United States Patent and Trademark Office

APPLICATION NO.	F	ILING DATE	FIRST NAMED INVENTOR	ATTORNEY DOCKET NO.	CONFIRMATION NO.	
10/688,335	•	10/17/2003	James M. Booe JR.	3282-72278	3282-72278 2293	
23643	7590	02/15/2005	EXAMINER		INER	
BARNES &	& THORI	NBURG	EDGAR, R	EDGAR, RICHARD A		
11 SOUTH	MERIDIA	.N				
INDIANAPOLIS, IN 46204				ART UNIT	PAPER NUMBER	
				3745

DETAILED ACTION

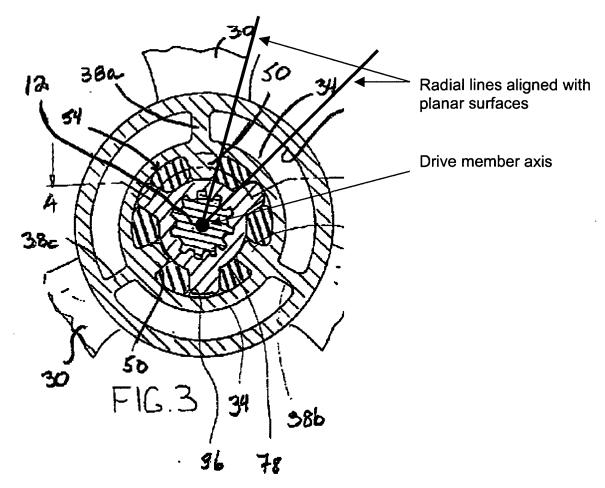
Chen shows a resilient member 56 arranged between alternating ribs which extend radially inwards 50 and radially outwards 86. The annotated Figure 3 on the next page shows how Chen teaches planar surfaces of the resilient member in radial alignment with the drive member axis. The planar surfaces are aligned with the drive member axis for the purpose of maximizing the torque transmitted through the propeller assembly.

Since Powers discloses polygonal resilient members 17-19 arranged between ribs which extend radially inwards and radially outwards, and Chen teaches that a resilient member having a polygonal cross-section should be arranged in the propeller assembly such that the planar surfaces are in radial alignment with the drive member axis for the purpose of maximizing the torque transmitted through the propeller assembly.
